ADDENDUM THREE

THE FOLLOWING CHANGES TO THE TENDER DOCUMENTS ARE EFFECTIVE IMMEDIATELY. THIS ADDENDUM SHALL FORM PART OF THE CONTRACT DOCUMENTS.

JOB École élémentaire catholique
Horizon-Jeunesse - Addition Phase II
CECCE

Subject: Ecole Elémentaires Horizon Jeunesse Tender Clarification - Addendum 2
DSS Clarification, Updated Figures, References to Architectural plans

GROUND FLOOR REFLECTED CEILING PLAN

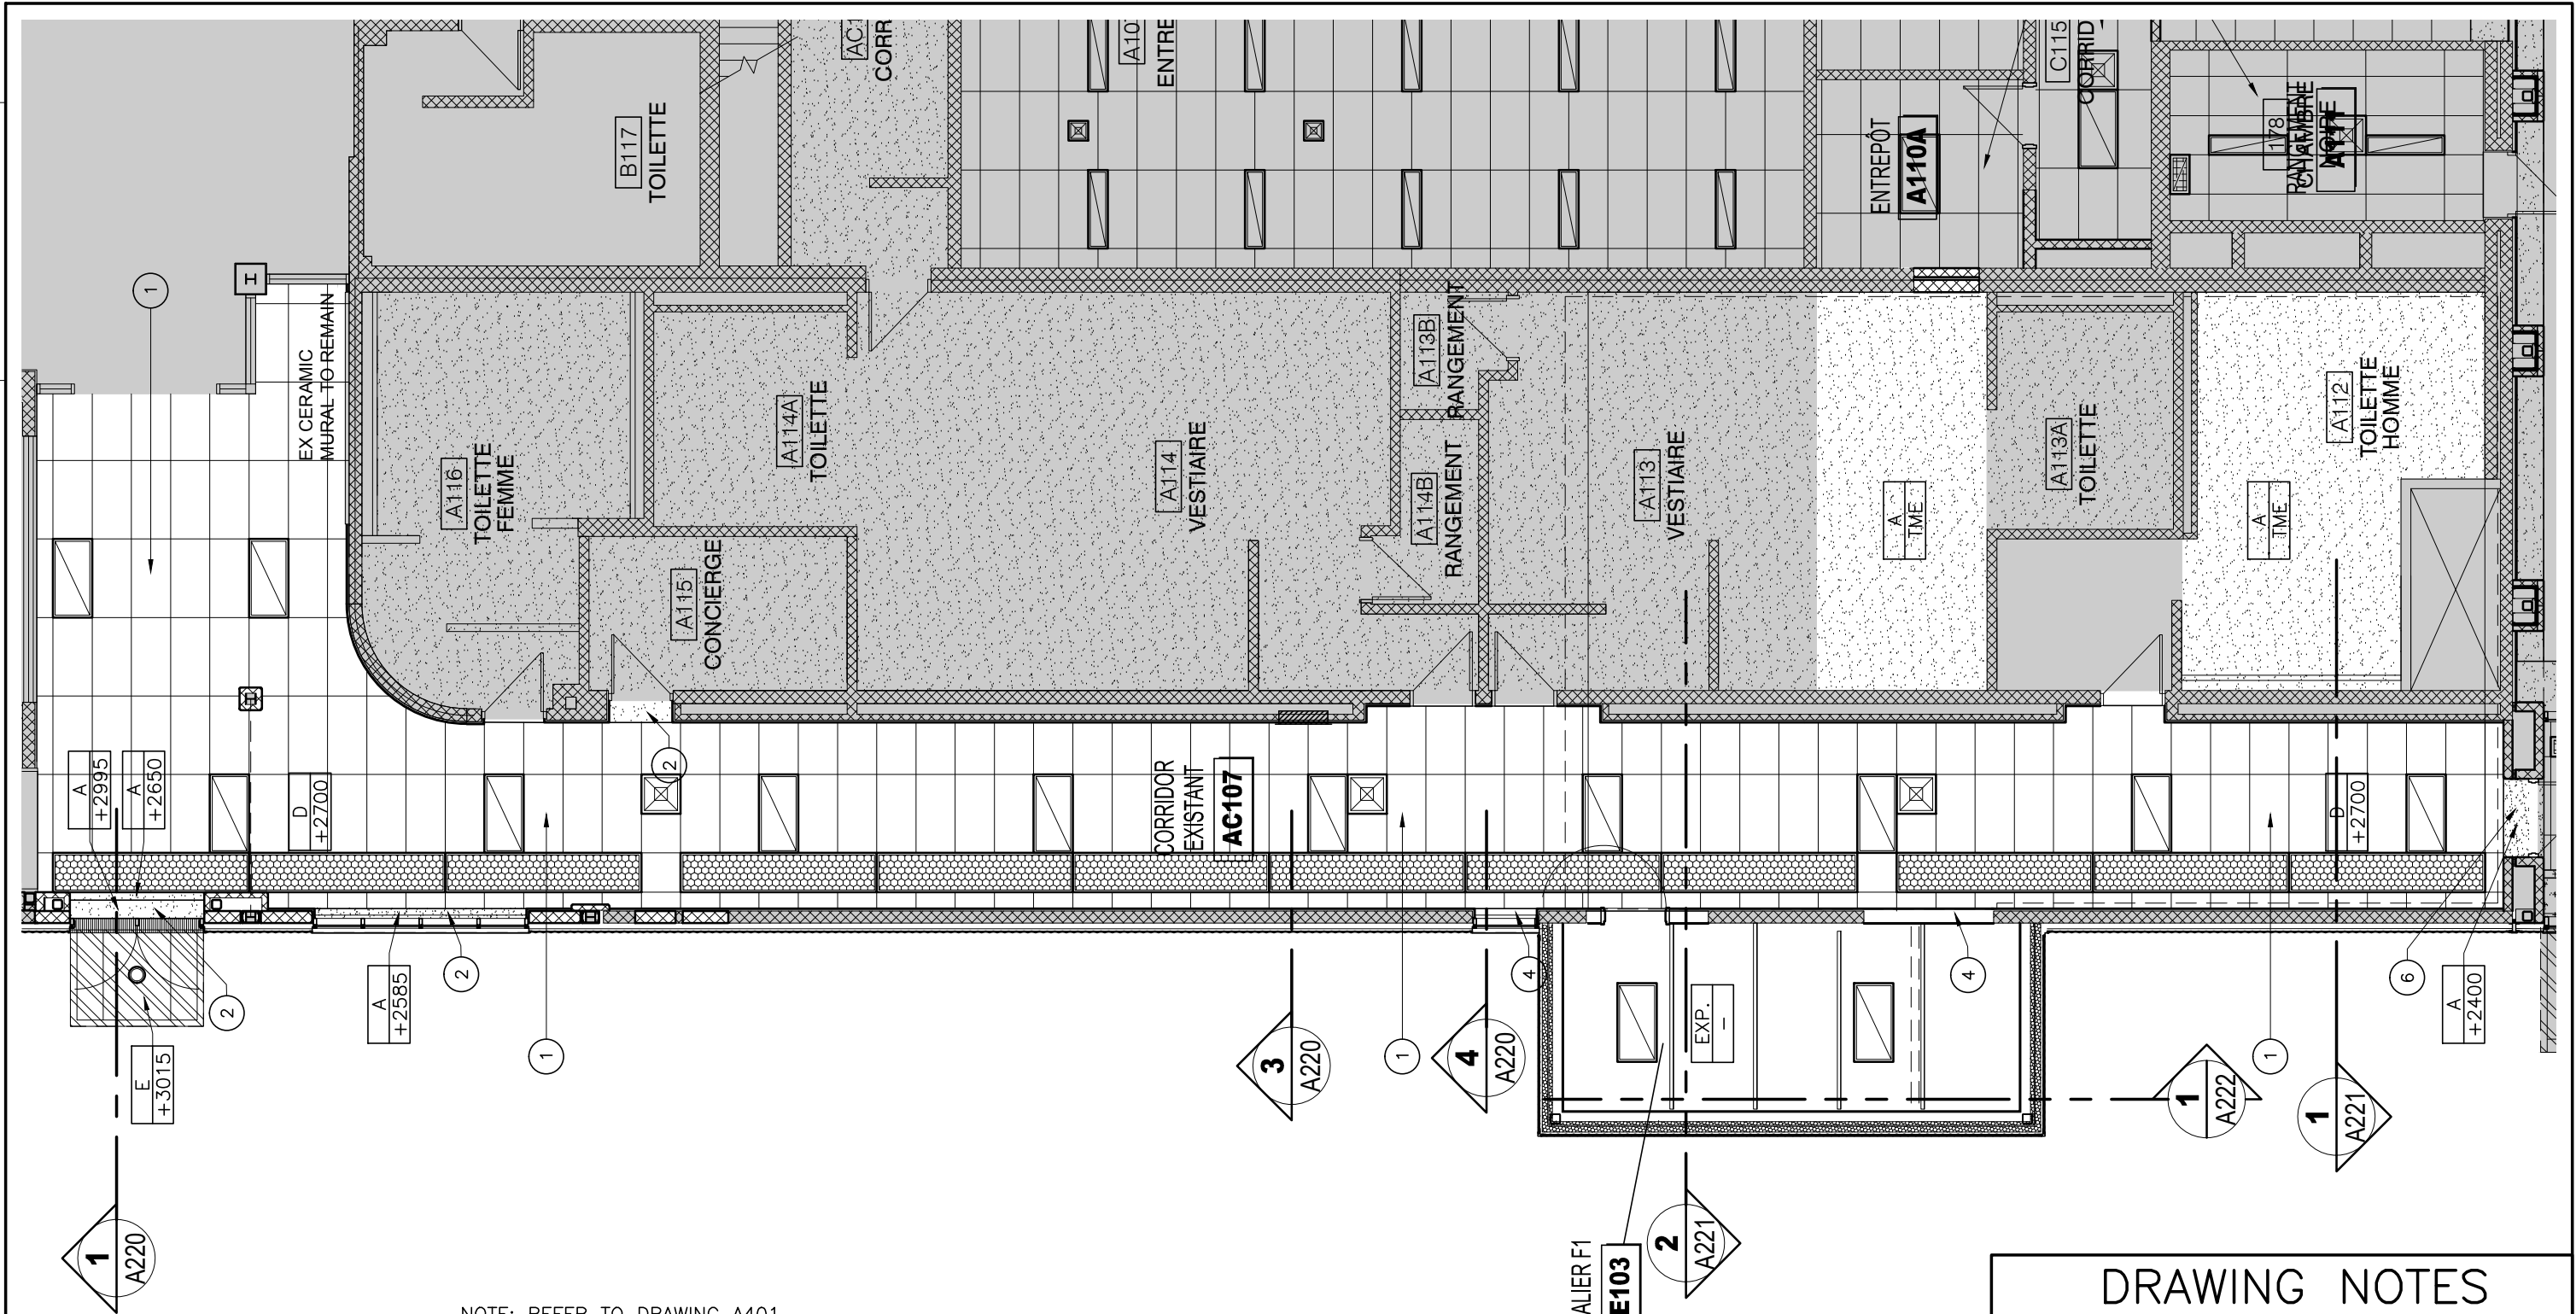
DRAWING NOTES	
⑥	NEW GYPSUM BOARD BULKHEAD

FIG 1

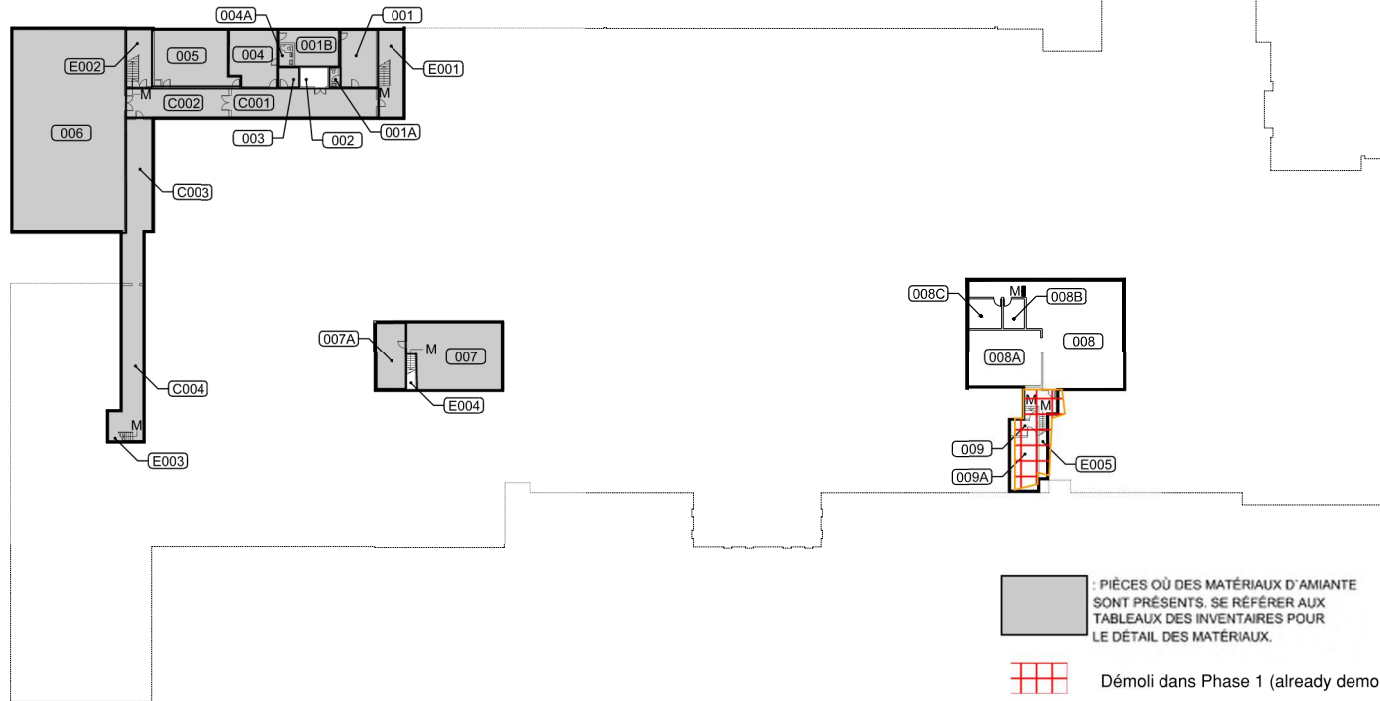
It was requested that a figure with room numbers and corresponding locations documented as having asbestos be provided. EXP has included the 2019 annual inspection as part of this addendum to display all the floor plans, corresponding room numbers and locations where asbestos has been identified. The annual inspection figures / floor plans (Figure 1 & 2) within that report have been updated to display the locations where demolition has already occurred within the Phase 1 Demolition program..

Although the report referred to the 2018 Annual Inspection Report (since field work was conducted in the winter and spring of 2019), please refer to the 2019 annual asbestos inspection as well for additional information (asbestos location plan, room numbers) when reviewing the February 27, 2020 Project Specific Designated Substances Survey Report, The 2019 annual inspection is the most up to date annual asbestos inspection and incorporates the information from the Phase I Abatement and Demolition Program. The 2019 annual inspection report replaces the former 2018 that was referenced in the February 27, 2020 Project Specific DSS.

PROJET:
VERMICULITE
INVESTIGATION -
EXTERIOR TEST HOLE
LOCATIONS ON GROUND
FLOOR

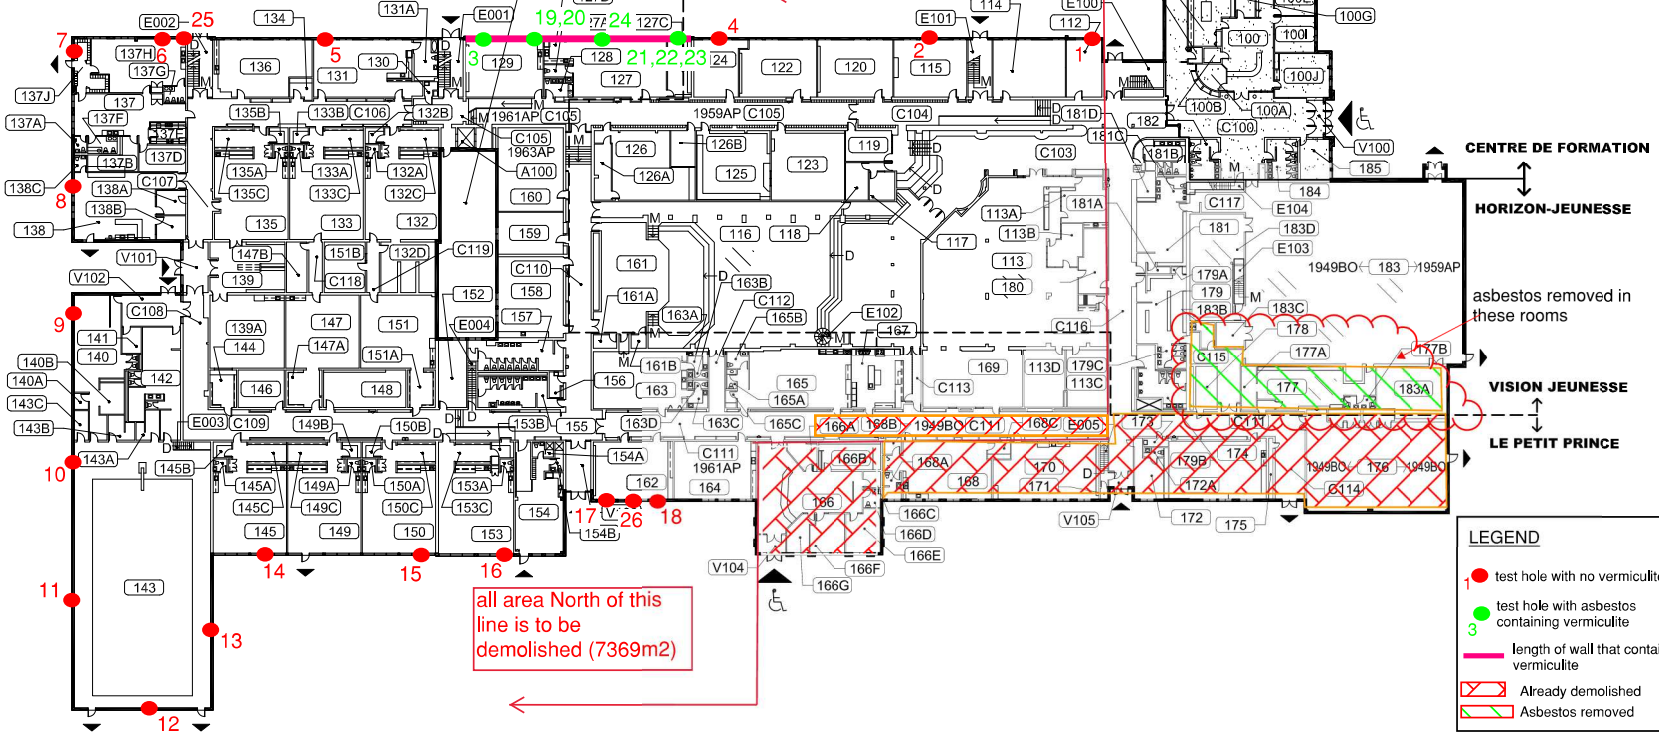
The February 27, 2020 Project Specific Designated Substances survey is limited to the Phase 2 demolition project only and summarizes all designated substances (asbestos, lead, mould and others) that will be disturbed and includes sample numbers, asbestos concentrations, etc.. The figure in the report has been updated to reflect where asbestos abatement and demolition occurred (Vermiculite Investigation Plan).
